# AG-CAT SERVICE NOTES and BULLETINS

**GRUMMAN** AMERICAN AVIATION  
CORPORATION

AG-CAT SERVICE BULLETINS

## SERVICE BULLETIN INDEX

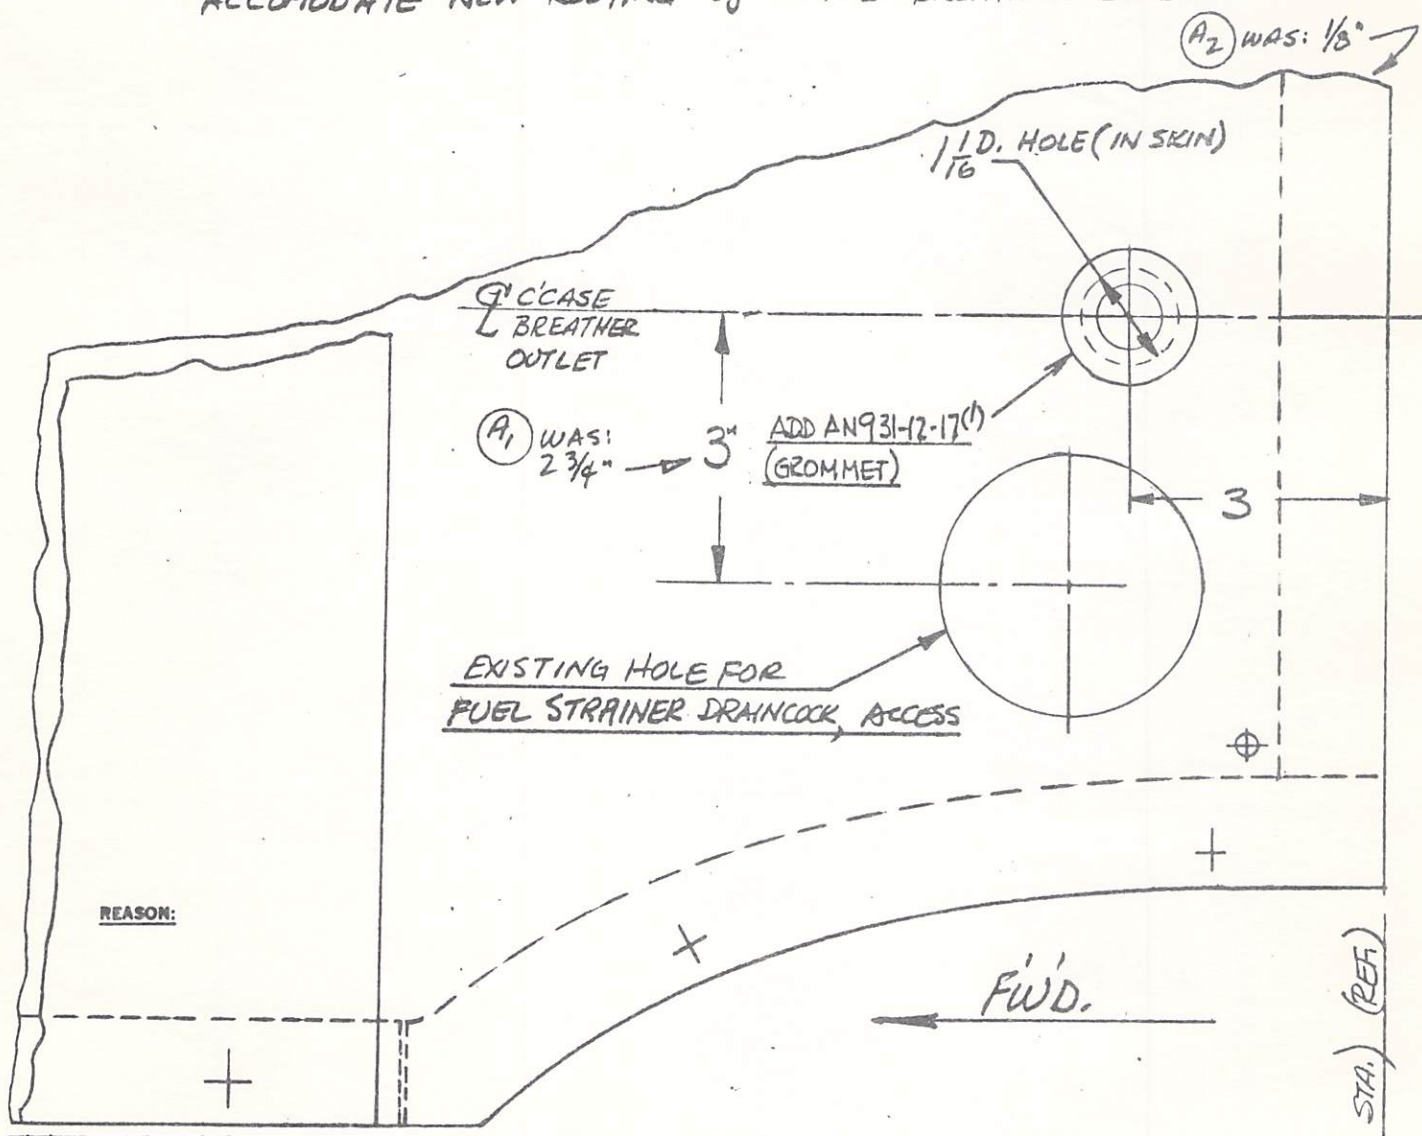
CHANGE: ADD THE FOLLOWING DETAILS TO LOWER L.H. COWL PANEL TO  
ACCOMMODATE NEW ROUTING OF C'CASE BREATHER LINE

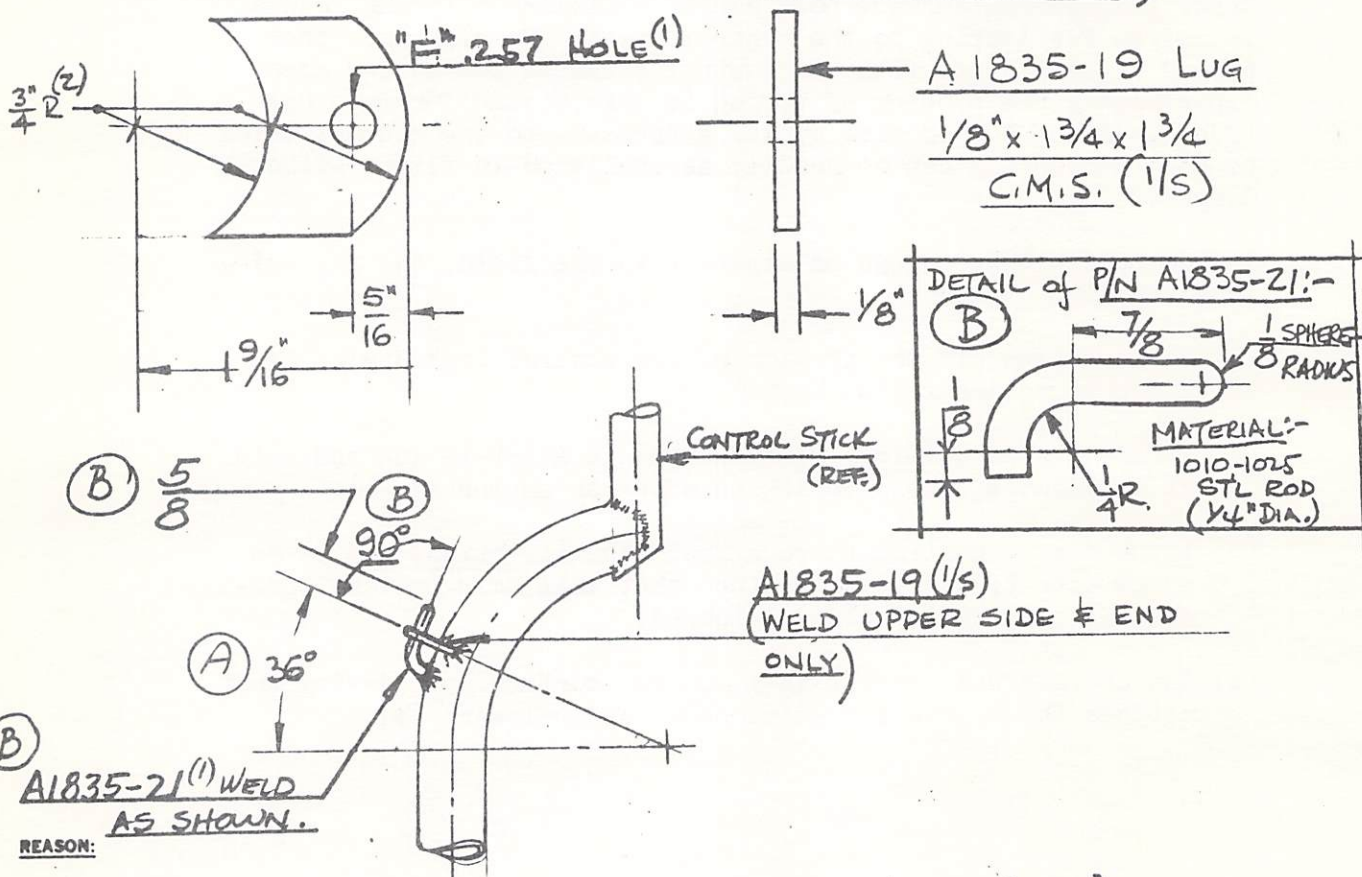
1. Add DETAIL & INST'L OF CONTROL LOCK LUG AS SHOWN BELOW:  
 (B) P/N -21 ADDED (SEE DETAIL) IN PRODUCTION ON A/C 311, UP. (INSTALLED ON A/C 301 → 310 IN THE FIELD PER SERVICE BULLETIN #29)

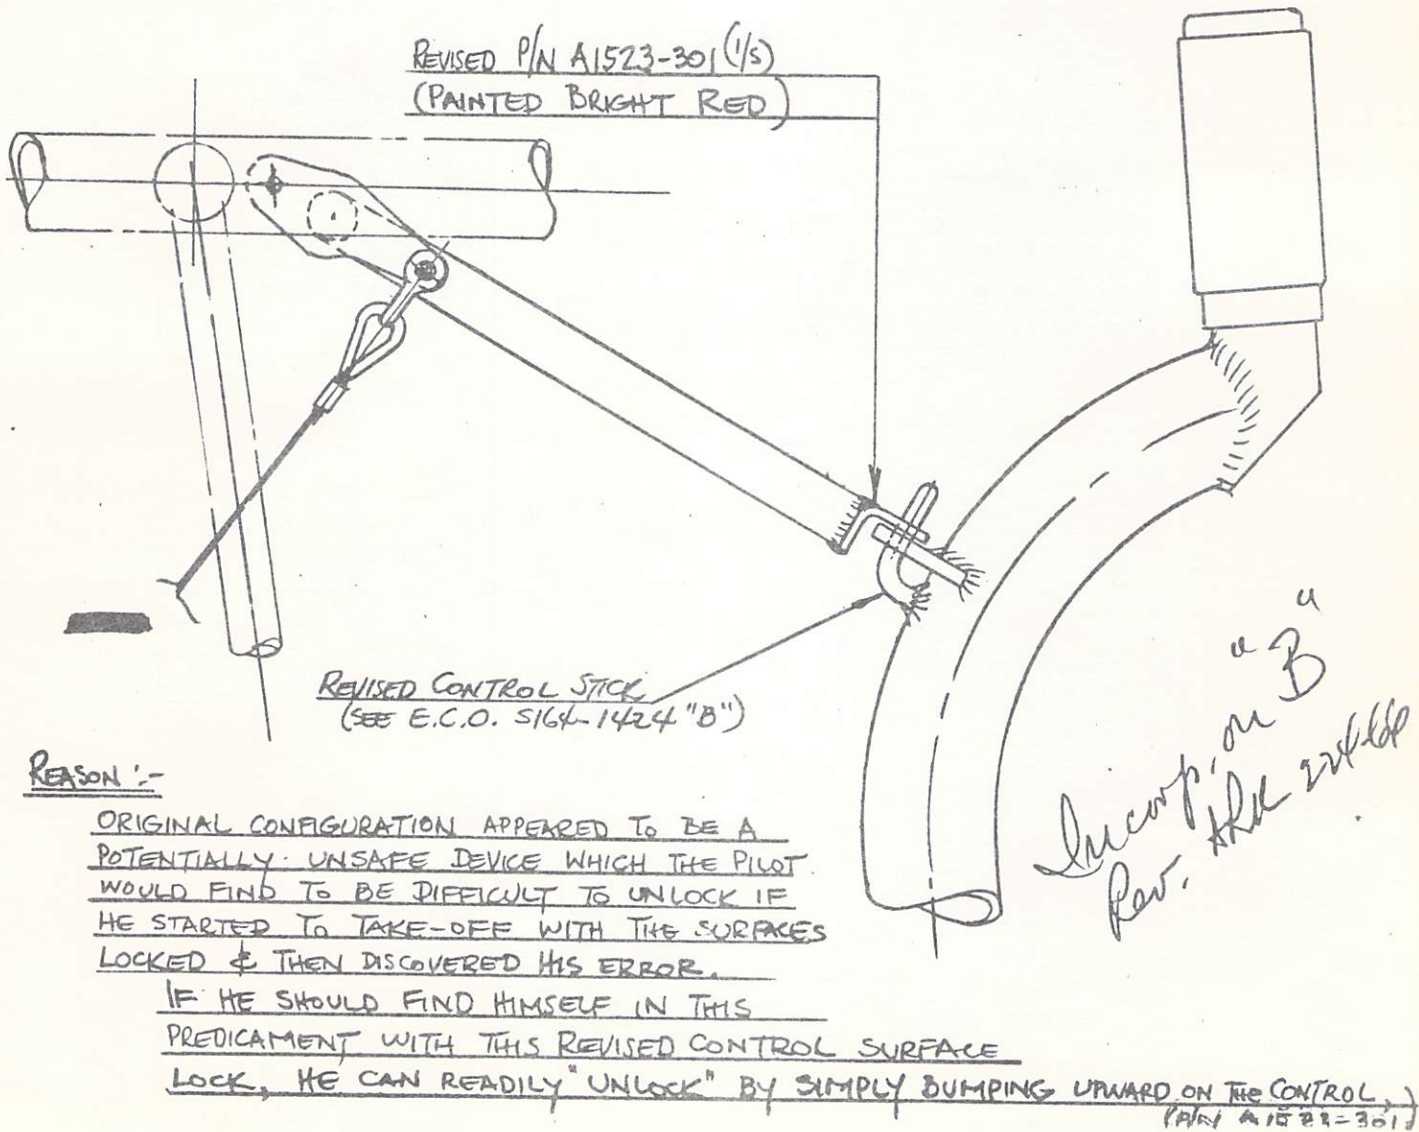
1. REVISE DWG A1521 "A" (SHT 2) TO SHOW THE INSTALLATION OF PART NO. A1523-301 AT <sup>THE</sup> CONTROL STICK ATTACHMENT. THE REVISED PART WILL APPEAR AS SHOWN BELOW WHEN ATTACHED TO THE REISED CONTROL STICK ASSY. (ALSO SHOWN BELOW IN REVISED CONFIGURATION) :-

SKETCH SHOWING REWORK REQUIRED TO BE DONE ON CONTROL SURFACE LOCK

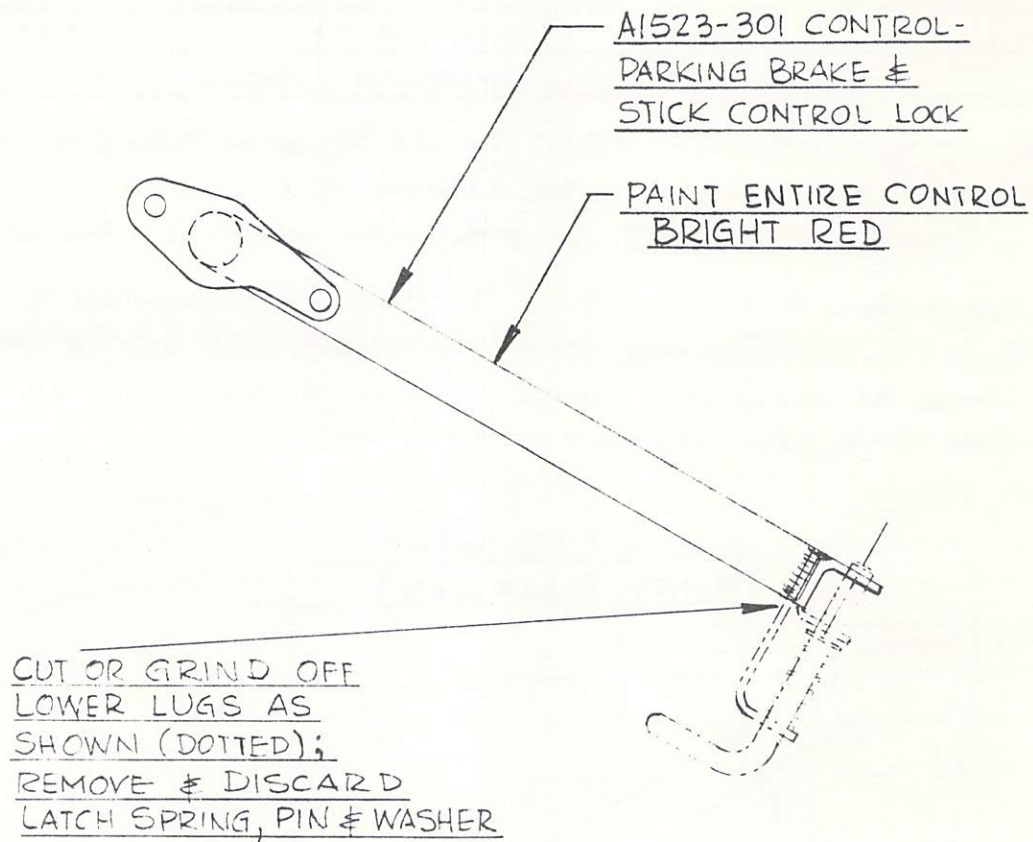
2. To accomplish this change on aircraft in the field, the following steps shall be taken:
  - (a) Saw or grind off the portion of the control lock device as shown on enclosure (c) Sketch.

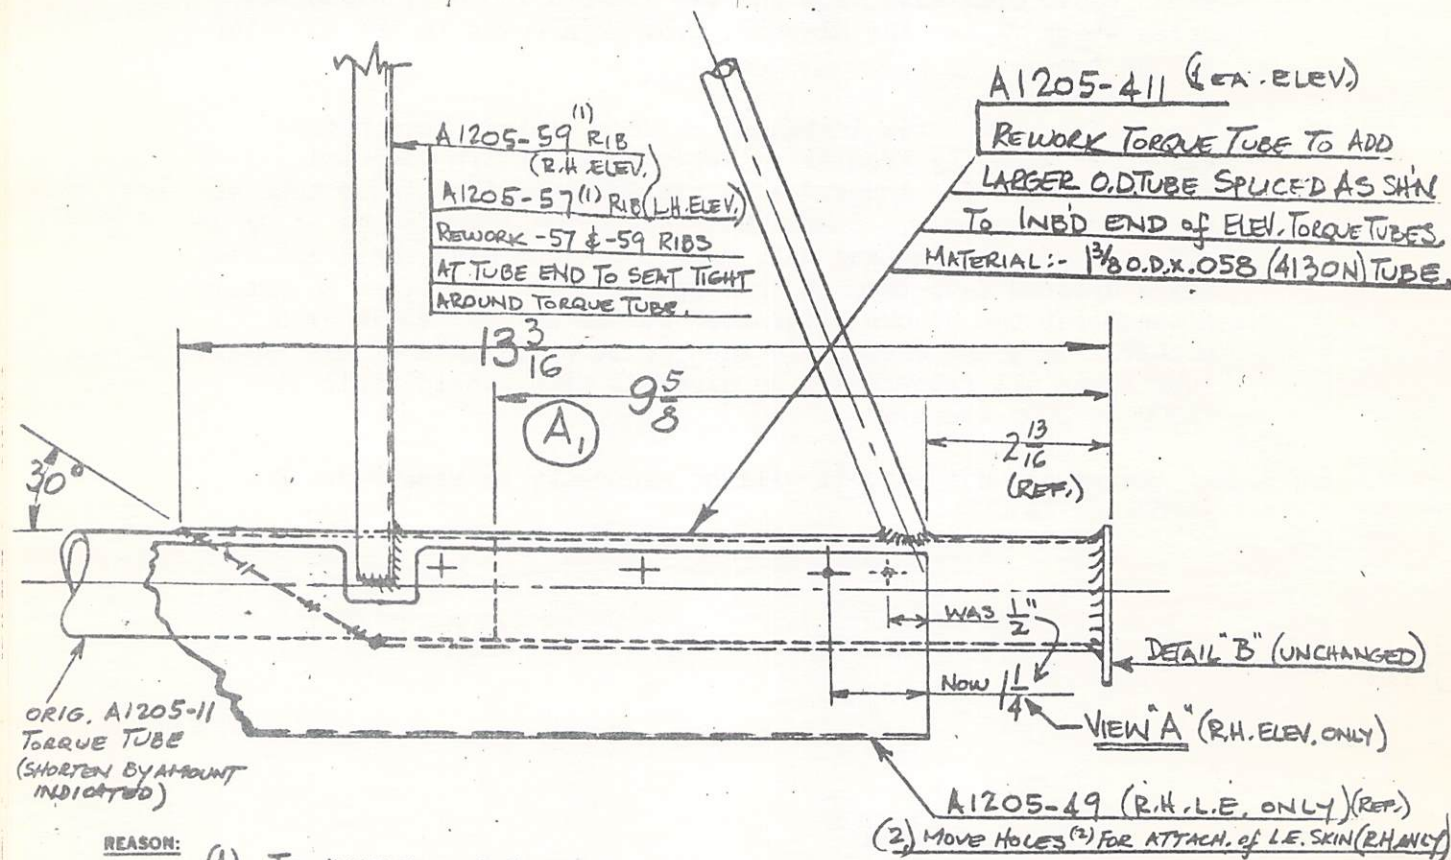
CHANGE: (1) ADD 1 3/8 O.D. X .058 TORQUE TUBES (P/N A1205-411) (1 EA. ELEVATOR) ON INBD ENDS <sup>BY SPlicing</sup> AS SHOWN BELOW ON -3/-4 WELD ASSYS. (THIS REDESIGN WILL ALSO APPLY TO ALL REPAIRS MADE TO ELEVATORS IN THIS AREA.)

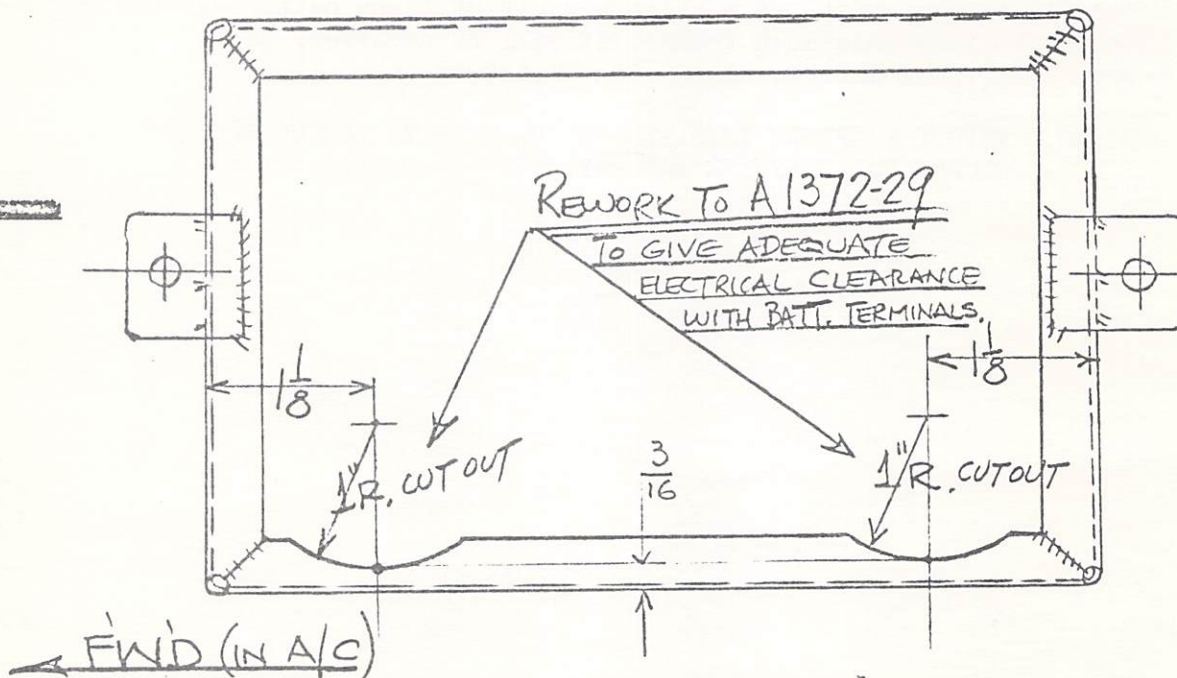
EFFECTIVITY IS ON ALL G-164A A/C (401, UP) FITTED WITH A1372 ELECTRICAL SYSTEM. A/C 401 THRU 425 PLUS #447 & #450 WILL BE REWORKED IN SERVICE PER GRUMMAN SERVICE BULLETIN #38. ALL OTHER G-164A A/C ARE TO BE REWORKED PRIOR TO DELIVERY AT THE FACTORY AS SHOWN BELOW:-

- ① BEFORE STARTING REWORK OF A/C IN SERVICE, BE SURE TO REMOVE BATTERY GROUND CABLE AT THE BATTERY.
- ② REWORK A1372-29 BATT. HOLD DOWN FRAME AS SHOWN BELOW:-

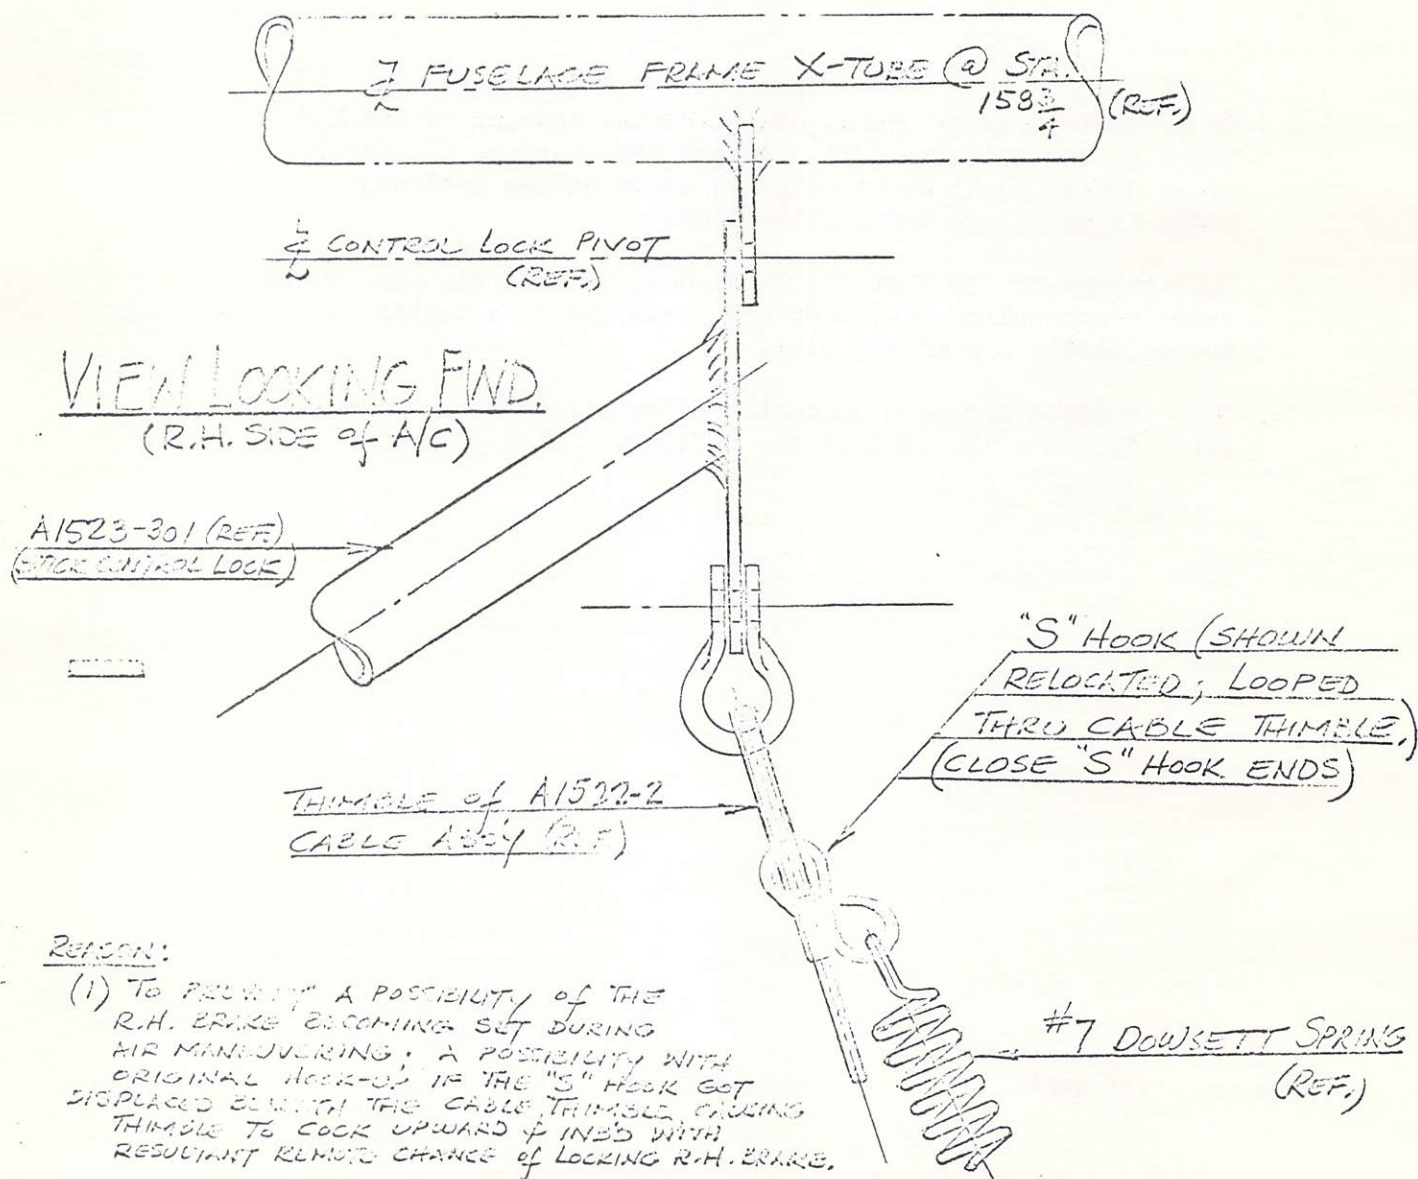
- ① DISCONNECT "S" HOOK THAT ATTACHES UPPER END OF #7 DOWSETT TENSION SPRING (ON R.H. SIDE OF CONTROL LOCK) FROM AN 393-11 SHACKLE & RE-HOOK SAME INTO THIMBLE END OF A1522-2 BRAKE LOCKING CABLE ASSY AS SHOWN BELOW :-

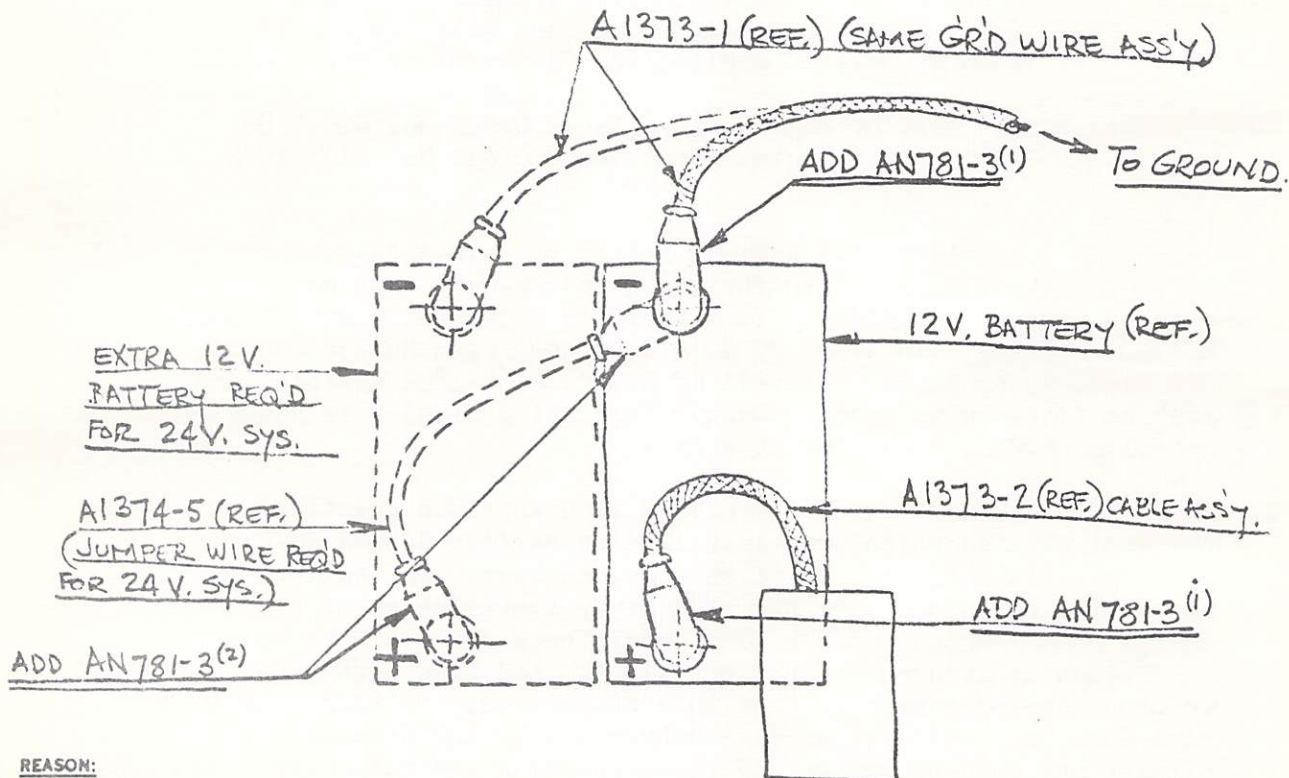
- ① ADD EITHER TWO (2) OR FOUR (4) AN 781-3 INSULATING NIPPLES, ELECTRICAL TERMINAL TYPE, TO 12VOLT OR 24V. BATTERY TERMINAL LEADS AS SHOWN BELOW IN SKETCH FORM:—

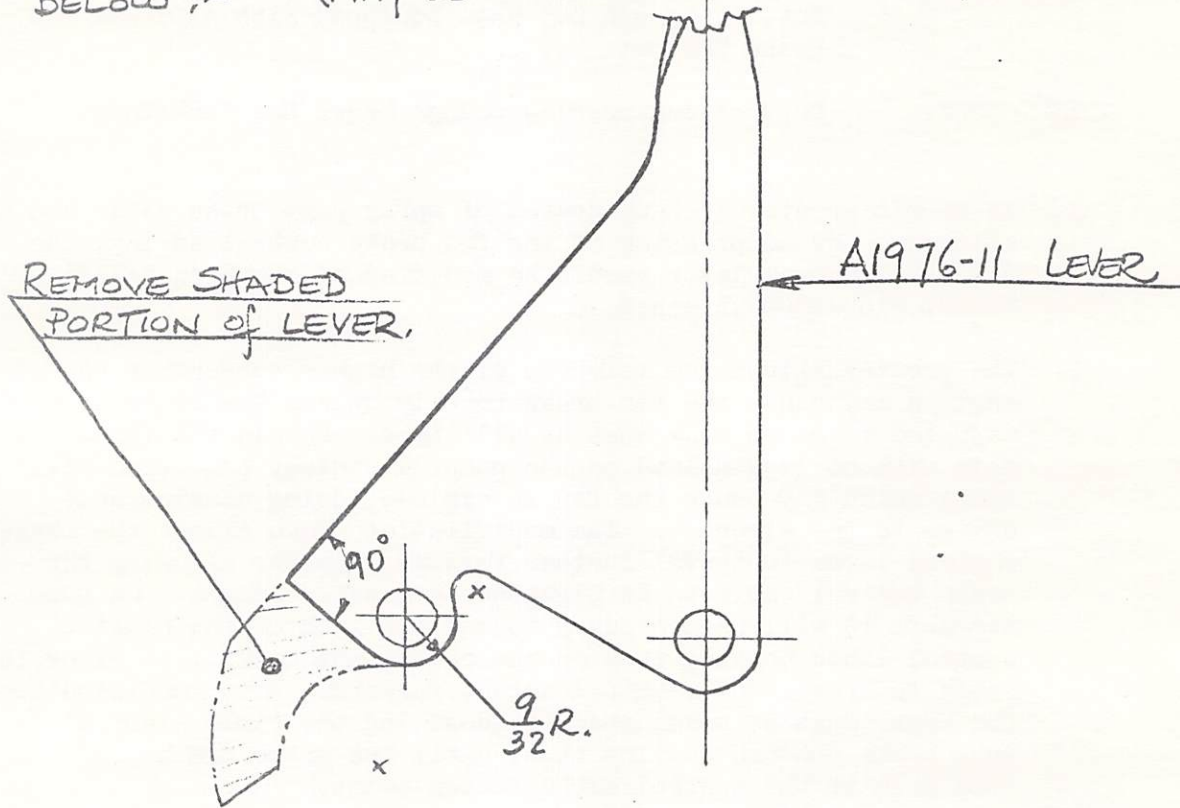
1. CUT OFF STOP PORTION of -11 LEVER AS DETAILED BELOW;— (MAY BE BACK-FITTED ON ALL A/C)
